Item Name: Dual High Back Seat

Reference: ECN 12-667 - Rework

DART SERVICE INSTRUCTION
TO AMEND INSTALLATION INSTRUCTIONS IIN-D350-689 REV. B
AND INSTRUCTIONS FOR CONTINUED AIRWORTHINESS ICA-D350-689 REV. 1
REF. TCCA STC: SH02-33
REF. FAA STC: SR01620NY
REF. EASA STC: EASA.IM.R.S.01453
REF. TCA STC: 2005S03-09

1.0 PURPOSE

FIGURE 1: UPDATES TO CROSS SECTIONS F-F AND M-M
 With reference to Figures 5 and 7 of IIN-D350-689
 (Figures 25-5 and 25-7 of ICA-D350-689)

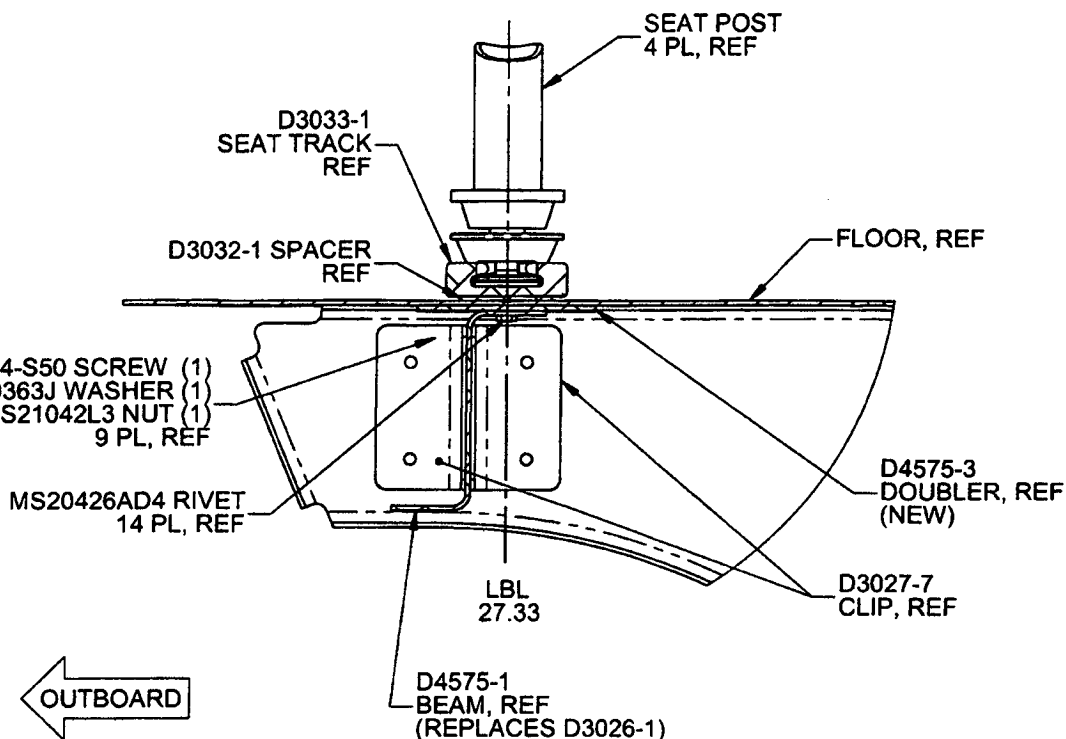
If there is an existing stringer at LBL 27.33, it will need to be removed from that location. Locate D4575-1 Beam, D4575-3 Doubler, and D3032-1 Spacer as shown in Figure 1 of this Service Instruction. Transfer drill existing holes from the aircraft floor to the D4575-1 Beam, D4575-3 Doubler, and D3032-1 Spacer. Ensure 1.0" to 1.5" rivet pitch and add additional holes if required. If there is no existing stringer, locate D4575-1 Beam, D4575-3 Doubler, and D3032-1 Spacer as shown in Figure 1 of this Service Instruction and drill Ø0.128" holes on a 1.0" to 1.5" pitch.

Counter sink holes in the D3032-1 Spacer for MS20426AD4 rivets. Install D4575-1 Beam, D4575-3 Doubler, and D3032-1 Spacer to floor using MS20426AD4 rivets.

FIGURE 2: UPDATES TO FIGURE 21 (IIN-D350-689) AND 25-21 (ICA-D350-689)
 With reference to Figures 19 and 20 of IIN-D350-689
 (Figures 25-19 and 25-20 of ICA-D350-689)

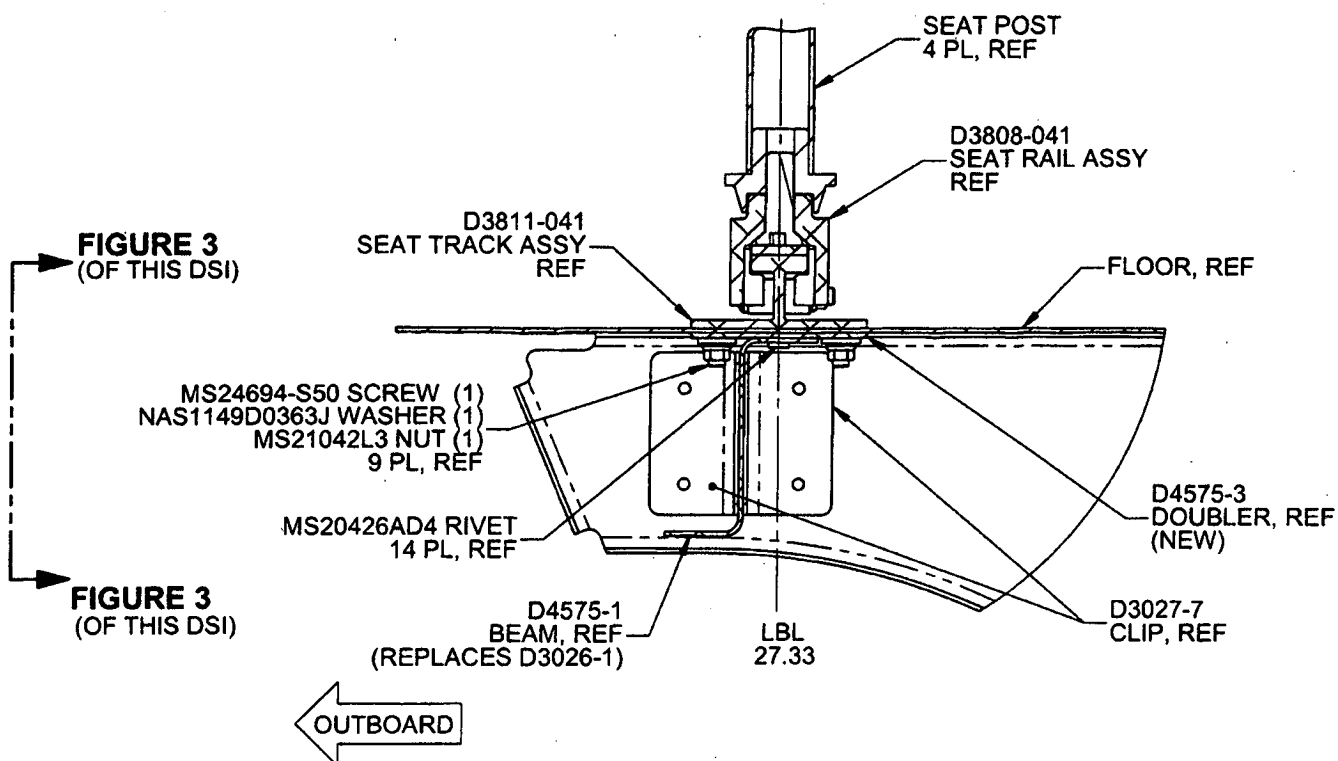
If there is an existing stringer at LBL 27.33, it will need to be removed from that location. Locate D4575-1 Beam and D4575-3 Doubler as shown in Figure 2 of this Service Instruction. Transfer drill existing holes from the aircraft floor to the D4575-1 Beam and D4575-3 Doubler. Ensure 1.0" to 1.5" rivet pitch and add additional holes if required. If there is no existing stringer, locate D4575-1 Beam and D4575-3 Doubler as shown in Figure 1 of this Service Instruction and drill Ø0.128" holes on a 1.0" to 1.5" pitch.

Attach D4575-1 Beam and D4575-3 Doubler to floor using qty (14) MS20426AD4 rivets.

FIGURE 3: RELIEFS ON D4575-1/-3
(ONLY D4575-1/-3 SHOWN FOR CLARITY)
VIEW LOOKING INBOARD

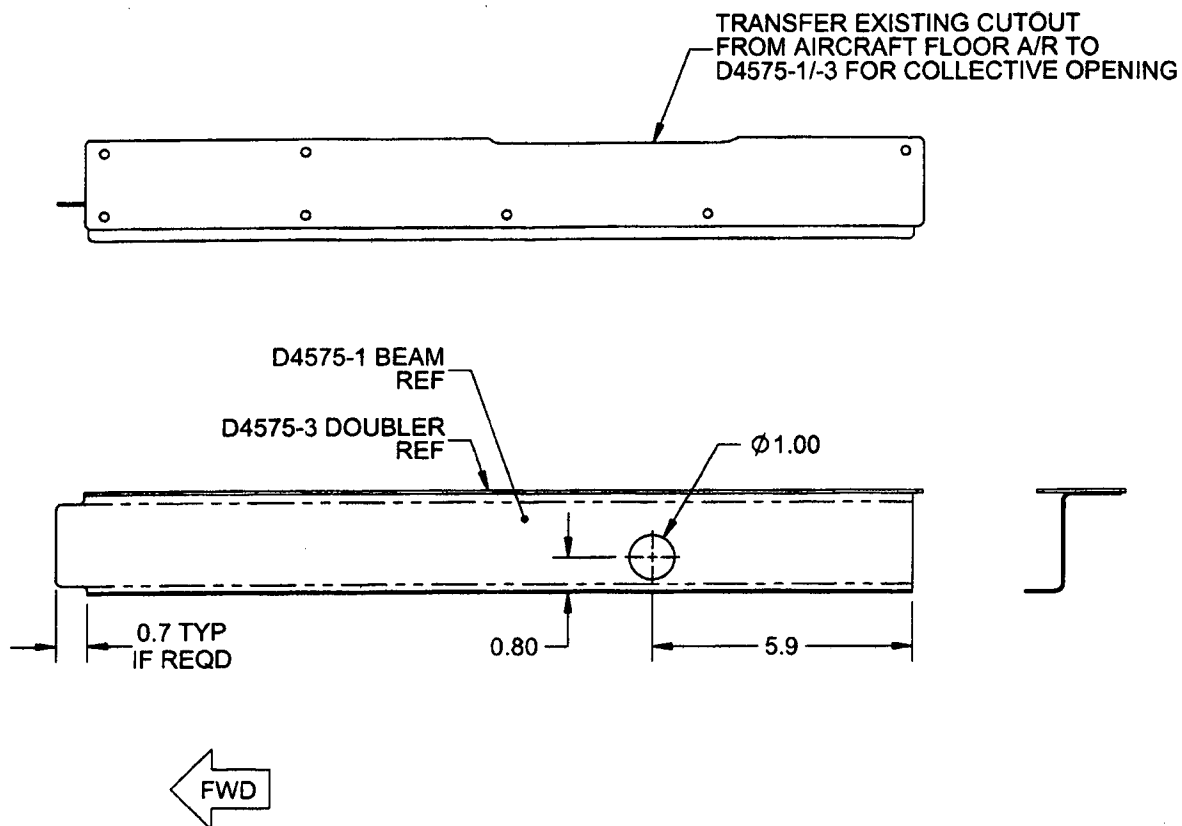
Note: Drill a Ø1.00" (Ø25.4 mm) hole in the D4575-1 Beam to clear extension tube of collective and cutout as required for clearance of collective opening and fwd bulkhead as shown in Figure 3 of this Service Instruction.

Note: Drill a Ø1.00" (Ø25.4 mm) hole in the D4575-1 Beam to clear extension tube of collective and cutout as required for clearance of collective opening and fwd bulkhead as shown in Figure 3 of this Service Instruction.
